## LINOTYPE IMPROVEMENT SHEET

NO. 283

## CHANNEL ENTRANCE LOCATING BLOCK

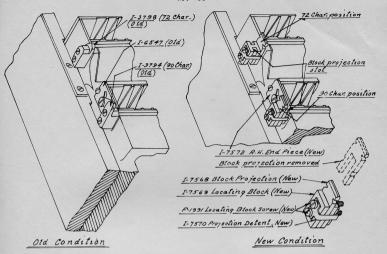
An improved construction has been designed for the Channel Entrance Locating Block which eliminates the necessity of removing and transposing as the present blocks on the Magazine Frames required herotofore.

This new construction is provided with a removable projecting piece that can be shifted from one slot to another in the new permanently located blocks.

Without disturbing the blocks, the projecting piece can be switched from 72 character entrance location to 90 character location and vice versa.

Can be applied to outstanding models 33(4)(72-90), 34(4)(72-90) by substituting four each of I-7568, I-7569, I-7550 and eight each of F-1991.

For Machines equipped with Magazine (Long) (90 Character) and (72 Character) substitute one of F-7572 (R.H.) End Fiece.
